Access Compliance Report

Public Rights-of-Way

(Curb Ramps)

Intersection ID: 31882	Main Street: STOWE_DERBY_DR	Cross Street: CENTERLINE_DR	Location: SW
ADA ID: 37147A712BC4	Ramp Type: PerpDiag	Initial Pass/Fail: Fail	Overall Compliance: No
		Severity Score: 35

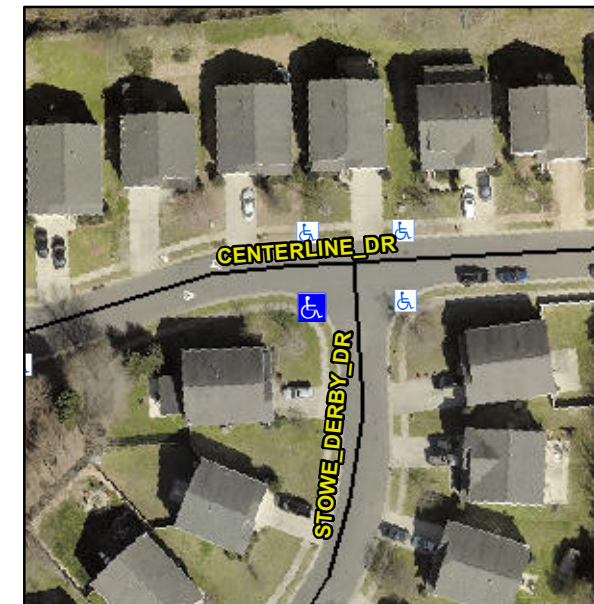
R304.5.1, R304.2.2, R304.5.3

Compliance	Description	Data	Compliance	Description	Data
N/A	Ramp Length (in)	49.0	No	Ramp Slope (%)	12.3
No	Ramp Width (in)	41.0	No	Ramp XSlope (%)	5.0
N/A	Flare Type LT	N/A	N/A	Flare Type RT	N/A
N/A	Flare Slope LT (%)	N/A	N/A	Flare Slope RT (%)	N/A
N/A	Flare Traversable LT?	N/A	N/A	Flare Traversable RT?	N/A
N/A	Landing Length (in)	N/A	N/A	DWS Provided?	N/A
N/A	Landing Width (in)	N/A	N/A	DWS Contrast?	N/A
N/A	Landing Slope (%)	N/A	N/A	DWS Length (in)	N/A
N/A	Landing X Slope (%)	N/A	N/A	DWS Full Width?	N/A
N/A	Landing Curb? (Y/N)	N/A	N/A	DWS Offset (in)	N/A
N/A	Shared Landing?	N/A			
N/A	Gutter Ponding?	N/A	N/A	Gutter Slope (%)	N/A
N/A	Gutter Lip Ht (in)	N/A	N/A	Gutter X Slope (%)	N/A
N/A	Painted X Walk1?	No	N/A	Painted X Walk2?	No
	X Walk 1 Direction	To SE		X Walk 2 Direction	To NE
N/A	X Walk 1 Width (in)	N/A	N/A	X Walk 2 Width (in)	N/A
	X Walk 1 Slope (%)	4.0		X Walk 2 Slope (%)	3.5
	X Walk 1 X Slope (%)	1.1		X Walk 2 X Slope (%)	5.9

Remove & Replace Curb Ramp With Two New Directional Ramps or Equivalent.
